CUSTOMER ADVISORY

ADV2602

Changes to Label Content on Altera Products

Issued: 01/30/2026

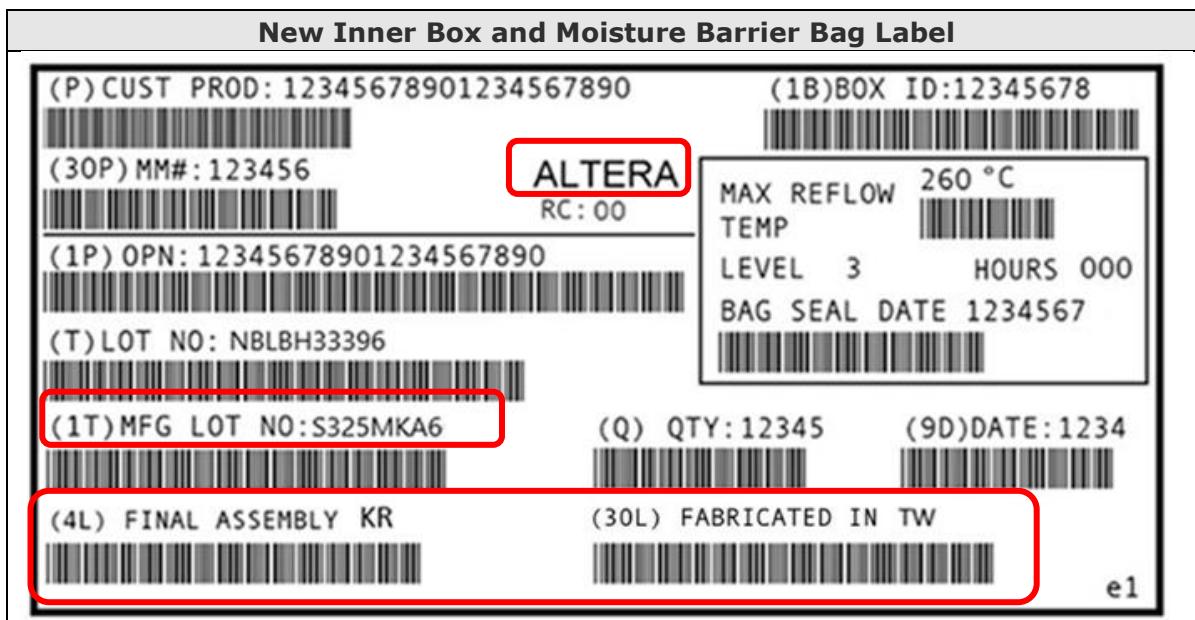
Altera is informing customers about upcoming changes to the label attached to the inner box and moisture barrier bag.

- “INTEL” name is replaced with “ALTERA”.
- Removed “(V) SUPPLIER” ID field as this no longer applies to Altera.
- Added “(1T) MFG LOT NO” which is additional lot level traceability.
 - Note: “(T)LOT” remains the main lot number.
- The previous Country of Origin (COO) barcode field is replaced with “FINAL ASSEMBLY” and “FABRICATED IN” human readable and barcoded fields.
 - Note: The applicable COO will vary based on the shipment destination. The Commercial Invoice and Packing List will include both the Country of Assembly (COA) and Country of Fabrication (COF) to provide and ensure accurately represented COO information.
